## **INSPECTION OF MAIN ROTOR BLADE**

**Mandatory  
Service Bulletin**

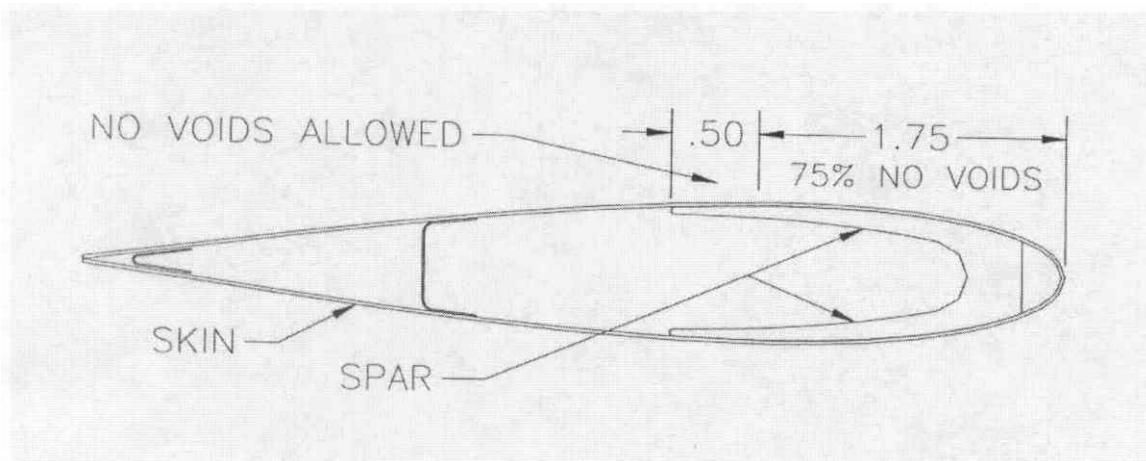
The tap inspection may be conducted using a coin (U.S. 25 cent piece or equivalent) or a small brass, steel, or aluminum hammer. Lightly tap the area over the spar as shown in the sketch below. A void will produce a tone change. The tone will be lower over the void. A method of "tuning" your ear is to tap from the leading edge of the blade towards the trailing edge. As you move pass the aft edge of the spar and over the unsupported skin, you will notice a distinctive lowering of the tone produced. Tap in a pattern with no more than 0.50 inches between taps in any direction.

Remove the rotor blade to be inspected from the helicopter and place it on a flat surface. Physically perform a tap inspection on both the upper and lower surfaces of the main rotor blade. Inspect the skin to spar bond from the inboard end of the blade to the blade tip in the spanwise direction and from the leading edge to the aft edge of the spar in the chordwise direction. The allowable void size (area) is 0.50 square inches except that no voids over 2.0 inches in length are allowed. There shall be 2.0 inches between voids except for the aft 0.50 inches of the spar where there are no voids allowed. Also, there are no voids allowed in any location in the inboard 12.0 inches of the blade. Measure the 12.0 inches from the inboard end of the blade not the end of the root fitting lugs. The upper and lower surfaces shall be considered separately.
